Access Compliance Report

Public Rights-of-Way

(Curb Ramps)

Intersection ID: N/A	Main Street: NORTHLAKE_PLAZA_DR	Cross Street: N/A	Location: S
ADA ID: AA1B83C769CC	Ramp Type: Perp	Initial Pass/Fail: Fail	Overall Compliance: No
Severity Score: 13.75			
Codes/Mitigation Info/Possible Solution		Field Measurements/Component Compliance

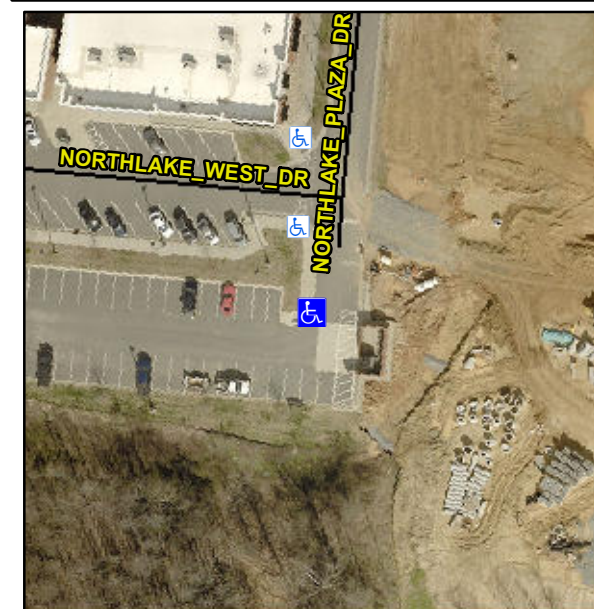
Remove & Replace Entire Ramp.

R304.2.2, R304.5.3

Compliance	Description	Data	Compliance	Description	Data
N/A	Ramp Length (in)	71.0	No	Ramp Slope (%)	9.5
Yes	Ramp Width (in)	48.0	No	Ramp XSlope (%)	3.5
N/A	Flare Type LT	N/A	N/A	Flare Type RT	N/A
N/A	Flare Slope LT (%)	N/A	N/A	Flare Slope RT (%)	N/A
N/A	Flare Traversable LT?	No	N/A	Flare Traversable RT?	No
N/A	Landing Length (in)	N/A	N/A	DWS Provided?	N/A
N/A	Landing Width (in)	N/A	N/A	DWS Contrast?	N/A
N/A	Landing Slope (%)	N/A	N/A	DWS Length (in)	N/A
N/A	Landing X Slope (%)	N/A	N/A	DWS Full Width?	N/A
N/A	Landing Curb? (Y/N)	N/A	N/A	DWS Offset (in)	N/A
N/A	Shared Landing?	N/A			
N/A	Gutter Ponding?	N/A	N/A	Gutter Slope (%)	N/A
N/A	Gutter Lip Ht (in)	N/A	N/A	Gutter X Slope (%)	N/A
N/A	Painted X Walk1?	No	N/A	Painted X Walk2?	N/A
	X Walk 1 Direction	To S		X Walk 2 Direction	N/A
N/A	X Walk 1 Width (in)	N/A	N/A	X Walk 2 Width (in)	N/A
	X Walk 1 Slope (%)	0.9		X Walk 2 Slope (%)	N/A
	X Walk 1 X Slope (%)	1.2		X Walk 2 X Slope (%)	N/A
